**Draft Supplementary Planning Document  
Compton Institute for Animal Health site**

**Council response to the supporting  
documentation to consultation response  
from Barton Willmore on behalf of  
landowner – Flooding Technical Note**

**Council response to the supporting  
documentation to consultation response  
from Barton Willmore on behalf of  
landowner – Landscape and Visual  
Appraisal Advice Note (April 2013)**

#### **Response to Consultation Response from Barton Willmore dated April 2013**

Designed by: JP	Drawn by: PN	Checked by: DF
Date: March 2013	Scale: 1:500 @ A1	
Dwg. No. 3820/SK01	Rev.

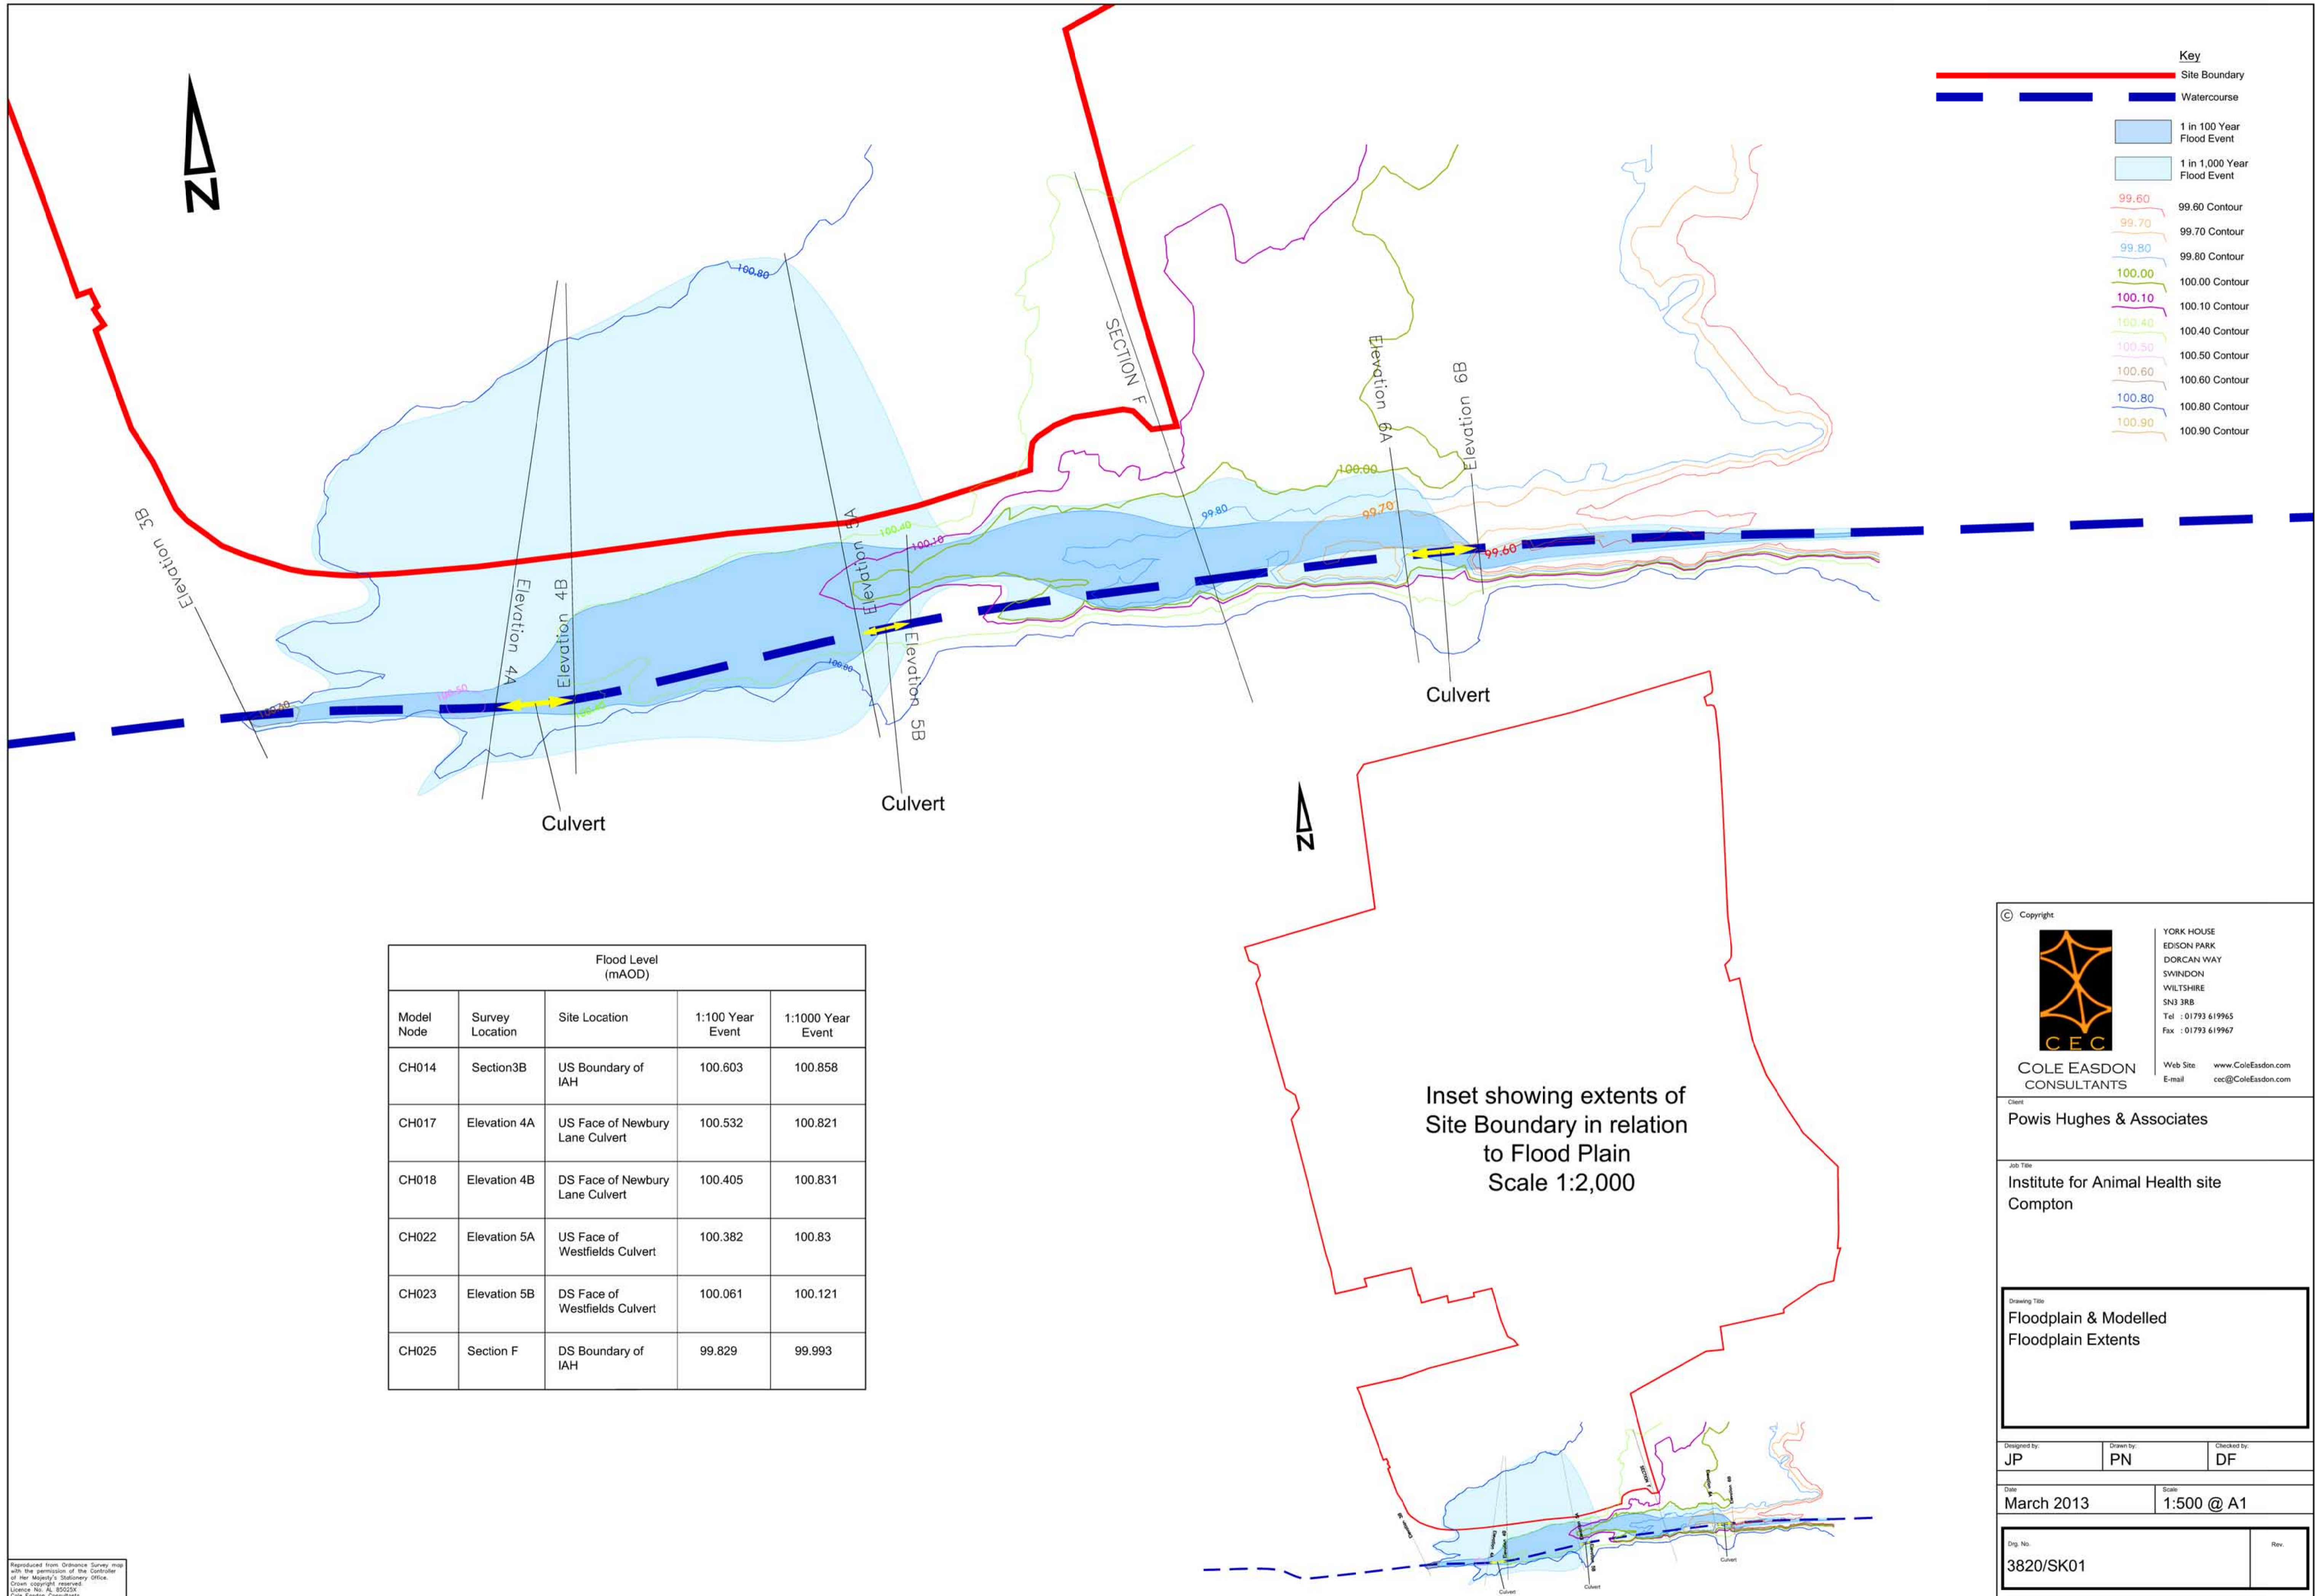
- 5.1 Figure 3820/SK01 shows that the modelled floodplain, even for the 1:1000 year event, is significantly below the 103m contour line and as such it is recommended that Council revise their advice within the Draft SPD accordingly.

Following the publication of the SPD, Cole Easdon Consultants produced a Technical Note (March 2013) which was submitted as part of the statutory consultation response from Barton Willmore, requesting that the above conclusion be revised. West Berkshire Council requested that the Cole Easdon Technical Note be reviewed and a response provided. This technical note therefore provides a response by Capita Symonds to the information presented by Cole Easdon Consultants and recommends that the existing conclusion should be retained.

- a) The flooding observed during the event of July 2007 was not observed to have exceeded 103m AOD;
- b) If the floodwater had reached 103m AOD in July 2007 then dwellings along High Street would have flooded to a depth of at least 3m; and
- c) An ISIS model of the River Pang, which was developed for the adjacent Greens Yard site and considered acceptable by the Environment Agency, does not show the extent of fluvial flooding to impact the site in a 1 in 100 year event and only affects a small part of the site in a 1 in 1000 year event.

The Cole Easdon Technical Note, therefore, essentially concludes that none of the above is consistent with a level of 103m AOD and that therefore the main conclusion of the SPD should be reviewed and revised accordingly.

As a result, neither the Cole Easdon Consultants nor Barton Willmore consultation responses are considered sufficient to reconsider or change any recommendations made in the Capita Symonds Flood Risk Study.

Project  
**Animal Health Institute  
Compton**  
Drawing Title  
**Concept Master Plan  
Option 2**

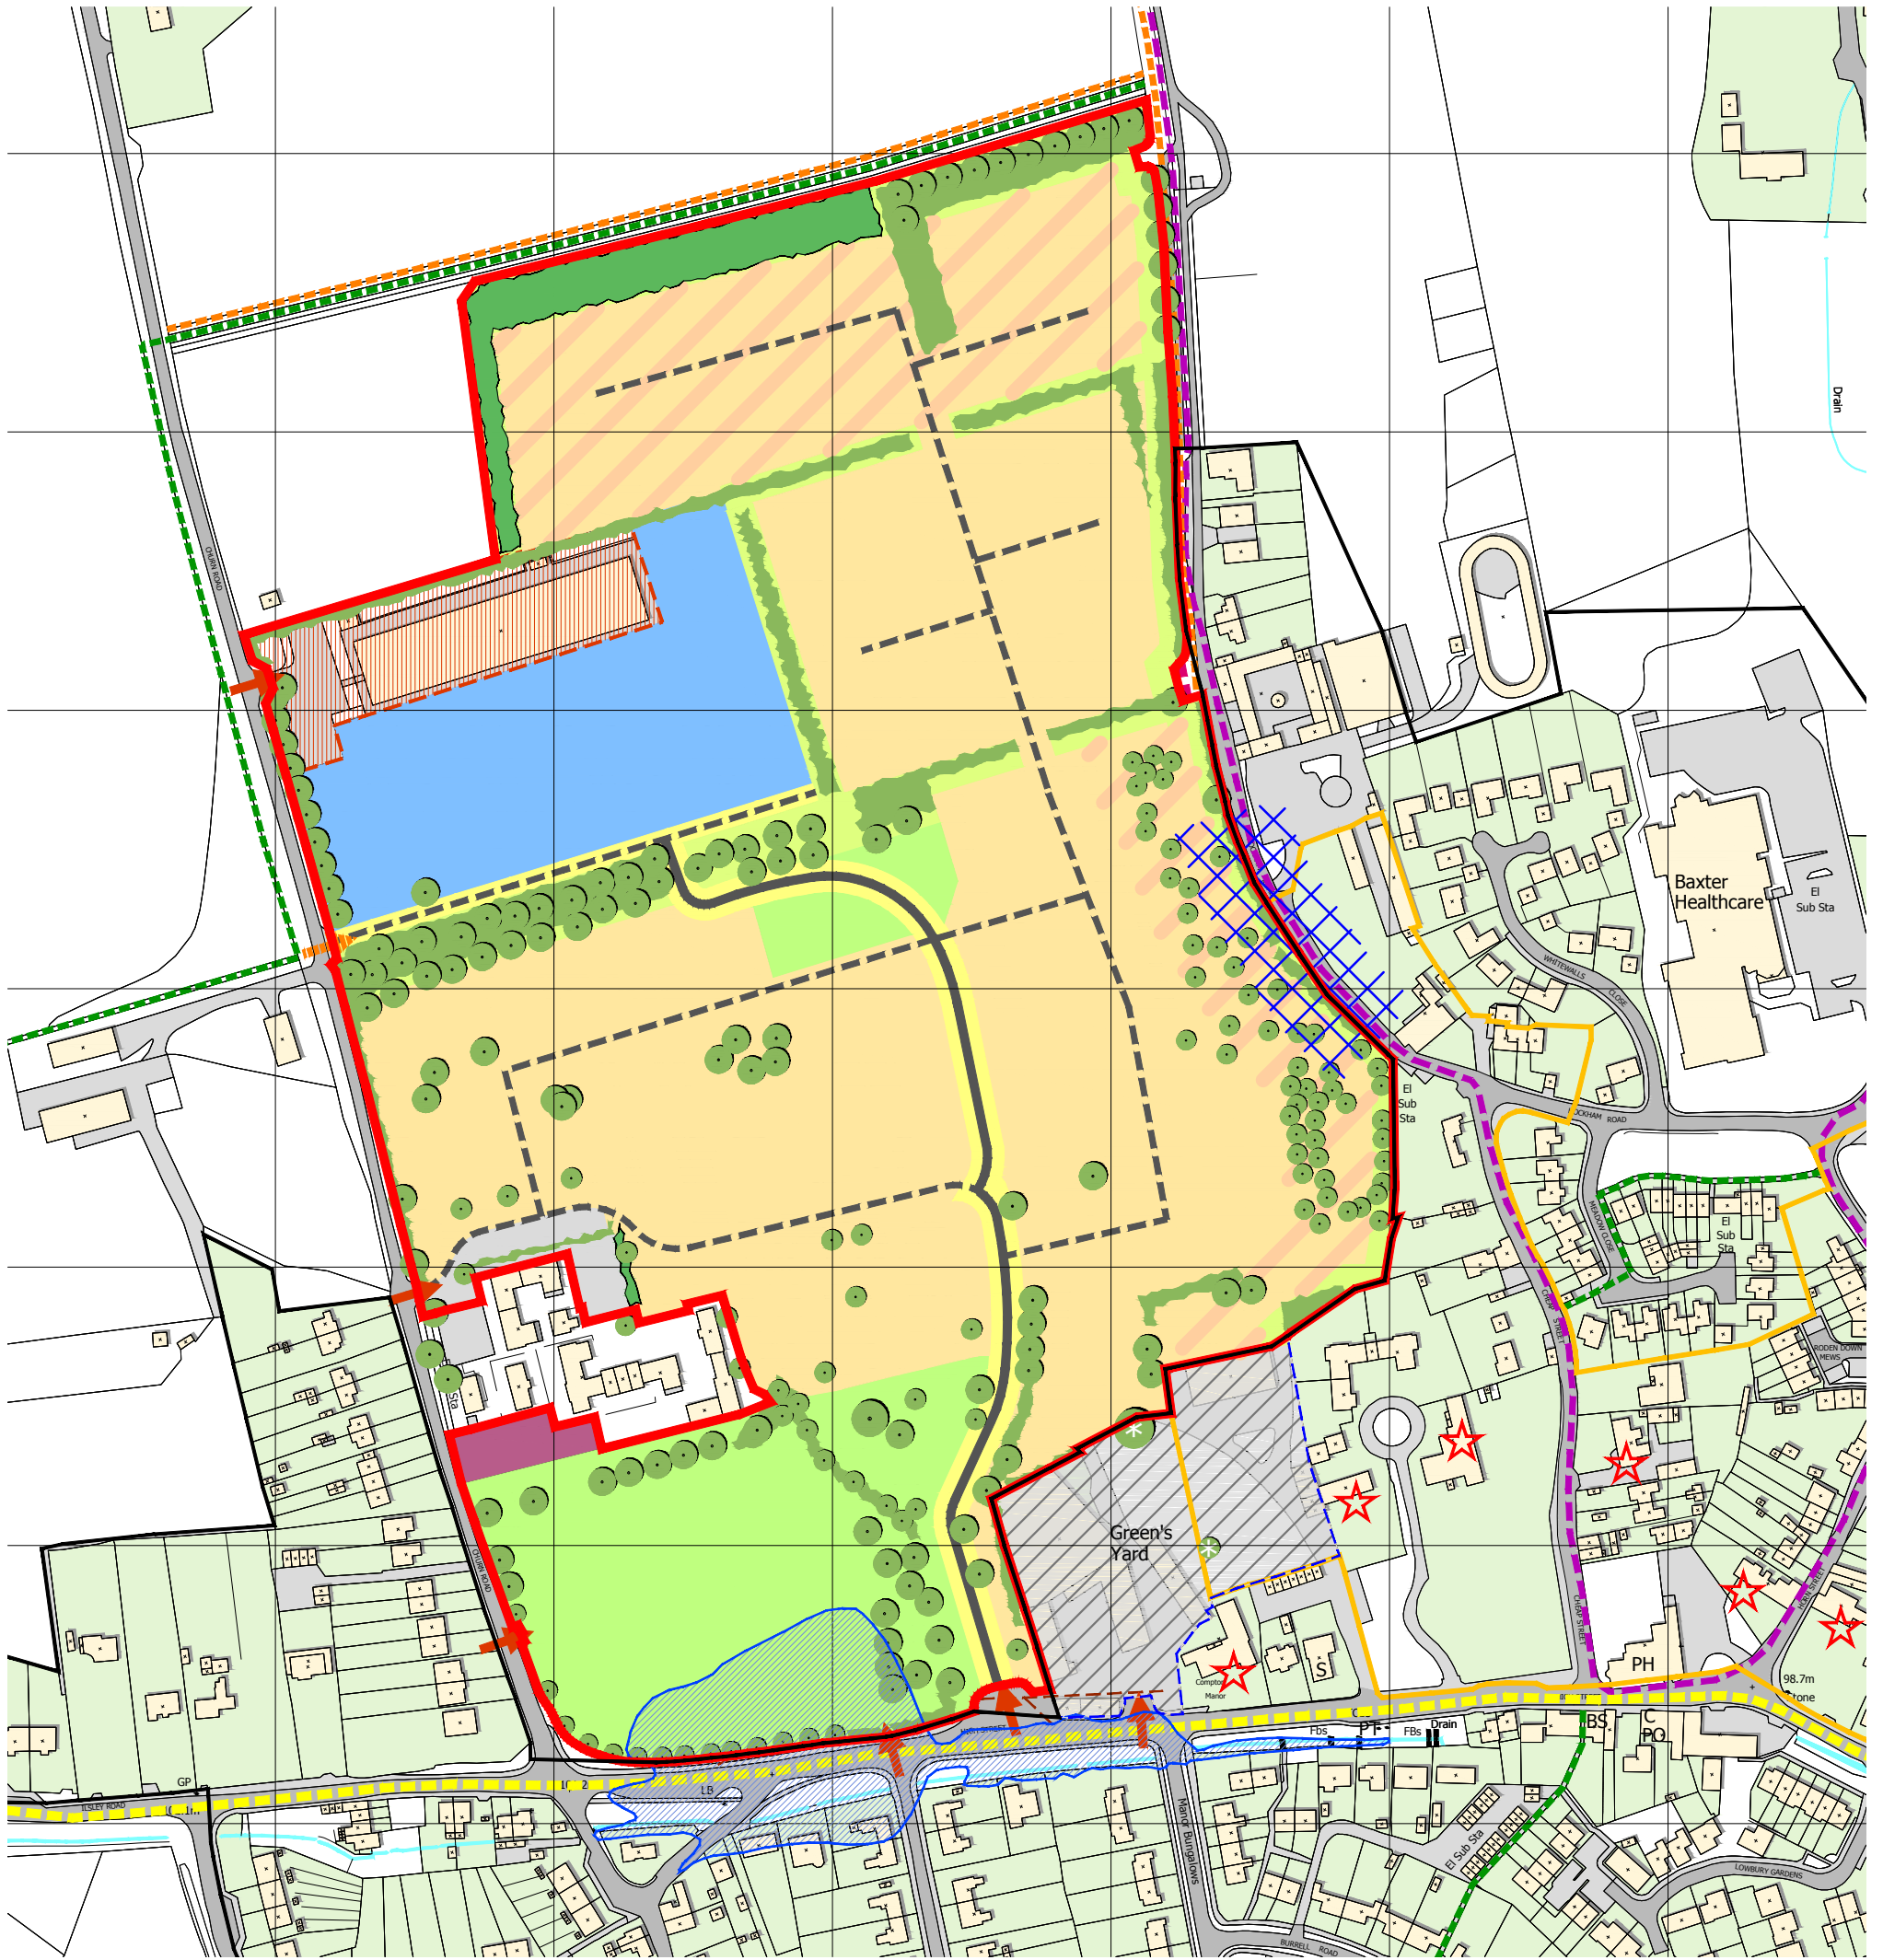
The SPD seeks to pull the open landscape setting of the site into the western edge of Areas B and C to create improved landscape and visual links with the adjoining countryside. Option 2 would urbanise Churn Road north of the village boundary point (Figure 4 Landscape Framework). The development edge should remain pulled into the site to allow for a soft open edge of a good width east of Churn Road. Option 2 is not in accordance with Development Principles LC4; G11; and G12.

This seems designed to screen development in Area A from views from the footpath and Churn Road. The SPD seeks to create a more transitional irregular soft edge to the settlement with visual links to the wider landscape. Option 2 supports Development Principles LC2; LC7; and G11 in part but planting along these boundaries must also be in accordance with LC1; LC3; and G12.

This is a key development objective and needs to be a part of any master plan option. Option 2 is not in accordance with Development Principles LC2; LC3; and G12.

- a) The proposed housing development area is shown across most of Area A, retaining the existing tree planting belts and introducing new belts to the north and west. This would increase the area covered by development in Area A (the east of Area A is predominantly open with an agricultural character). Housing would also be of a similar height to the existing sheds and extend the mass of built form over the whole area resulting in an increase in harm to the AONB. Area A will also appear virtually contiguous with Area B creating an estate which is of a scale which is out of keeping with Compton and the AONB settlement pattern.
- b) Area A is most visible from the adjoining PROW and from the east, locations where the village is to the south and do not form the setting of Area A. Area A is
